**U. S. EPR Standard Design Certification**

**SRP Section: 09.02.01 - Station Service Water System**

**Question 09.02.01-35:**

**Question 09.02.01-28:**

Figure 9.2.1-1—Essential Service Water System Piping & Instrumentation Diagram  
Sheet 1 of 4

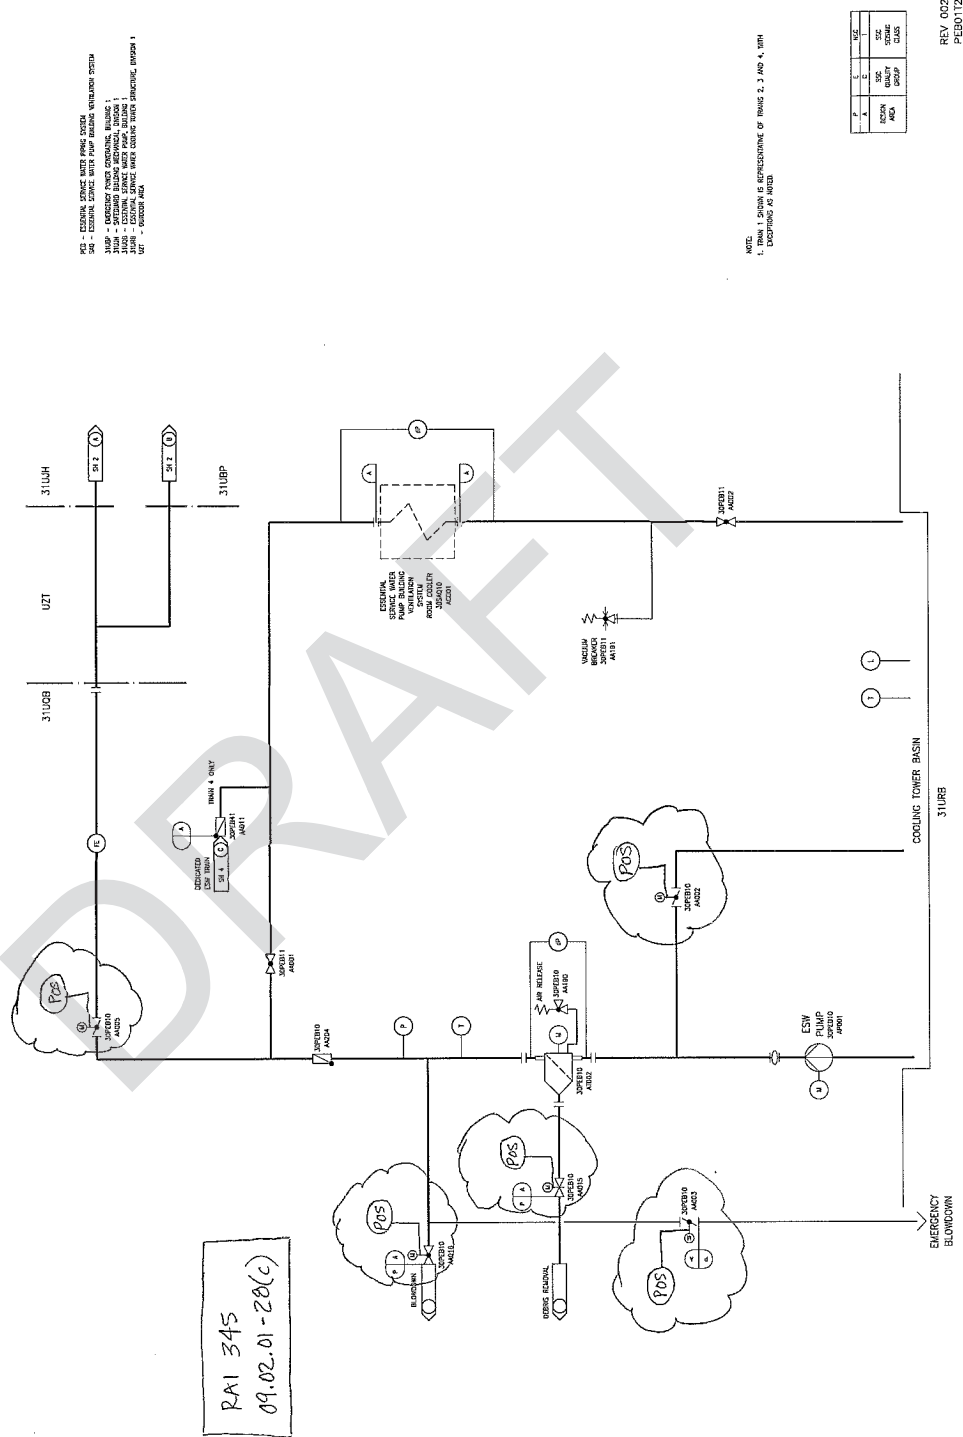
Part (c)- The P&ID does not show where indications are displayed (e.g., local, remote panel, control room), and what instruments provide input to a process computer and/or have alarm and automatic actuation functions.

The applicant should identify the continuation of the dedicated blowdown line from Figure 9.2.1-1, Sheet 4 of 4.

The dedicated blowdown line continues to the site-specific Common Retention Basin. FSAR Figure 9.2.1-1, Sheet 4 of 4 will be revised to indicate this destination.

U.S. EPR FSAR Tier 2, Section 9.2.1, Table 9.2.1-3 and Figure 9.2.1-1 will be revised as described in the response and indicated on the enclosed markup.
